## STAFF REPORT COMMUNITY DEVELOPMENT DEPARTMENT

SUBJECT: H-2020-0117  
 Shafer View Terrace – AZ, PP

Annexation of a total of 40.48 acres of land with R-2 (10.66 acres) and R-4 (29.82 acres) zoning districts; and Preliminary Plat consisting of 50 buildable lots and 10 common lots on 39.01 acres of land in the R-2 and R-4 zoning districts.

**1. BERM ADJACENT TO MERIDIAN ROAD**

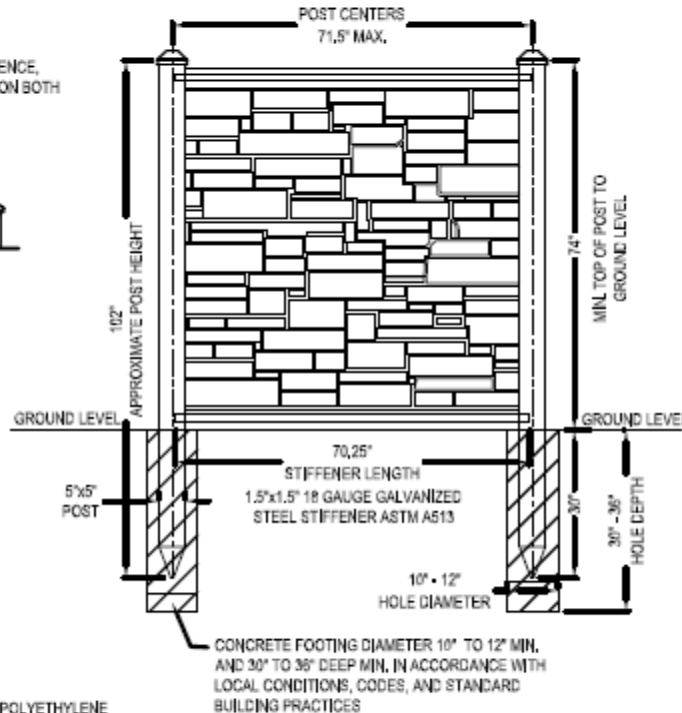
A 4-foot tall berm with a 6-foot tall solid wall by Simtek is proposed along S. Meridian Rd. as noise abatement as depicted on the detail on Sheet L1.0 of the Landscape Plan. Architectural elements are proposed to break up monotonous wall planes as required. ~~**A detail of the proposed wall that demonstrates compliance with the standards listed in UDC 11-3H-4D should be submitted with the final plat for the first phase of development.**~~ *Depicted on the revised landscape plan.*

- c. ~~Include a detail of the berm and wall required for noise abatement along S. Meridian Rd./SH-69 that demonstrates compliance with the standards listed in UDC 11-3H-4D. Done~~
